This is to inform you that a joint review of the Preliminary Overall Development Plan for Sky Harbor (File #83-12-54-24) has been conducted by Planning and Traffic staff. Specifically, said review focussed on areas for which plats have not been approved or recorded.

Sky Harbor

FILE NO. 83-12-54-24
(To be assigned by the Planning Dept).

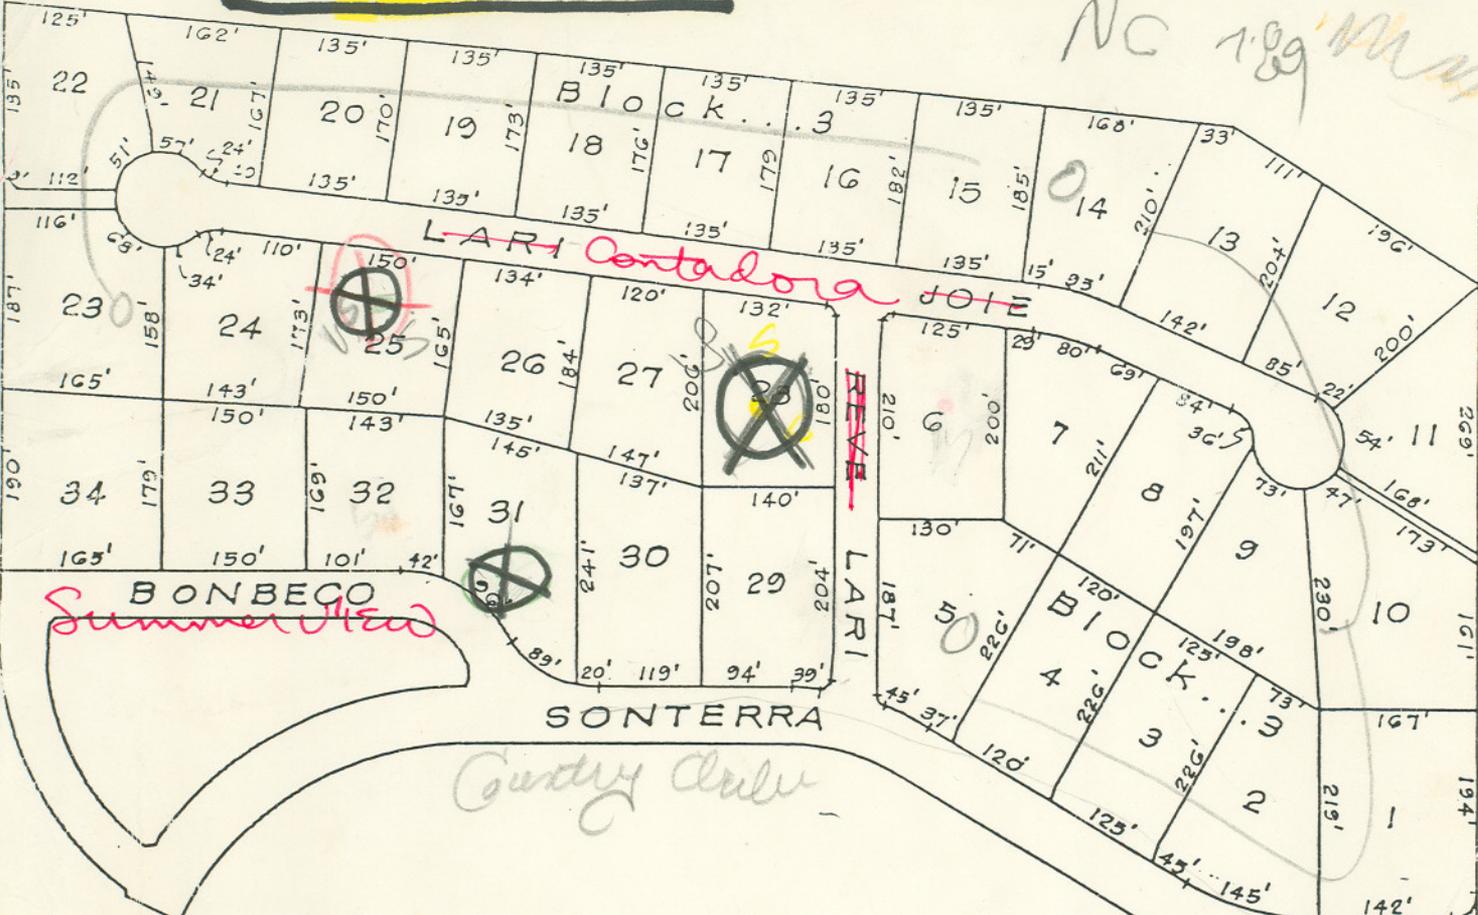
Based on the information made available to us by you, it is our understanding that all of the land depicted on P.O.A.D.P. has been developed with the exception of the parcel of land bounded by Old Sky Harbor, Portside, and the most easterly 50' drainage and multi-use easement and the variable drainage easement to the southwest. It has been concluded that the described area under review is in general compliance with Chapter 36. But we note that two planned cul-de-sac streets are in excess of 500' in length as referenced in Section 36-10(H) of the City Code. Therefore, it will be necessary for you, upon application of a Letter of Certification with the Department of Public Works, to address the facts which warrant the proposed design. As you know, the Commission will accept or reject a plan with longer cul-de-sac streets based on its merits after considering density, land use, safety and convenience. Additionally, Pearsall Road is classified as a secondary arterial type "A" (86' R.O.W.) on the Major Thoroughfare Plan. Any platting activity taking place along Pearsall Road will require dedication for future street widening in accordance with said thoroughfare plan.
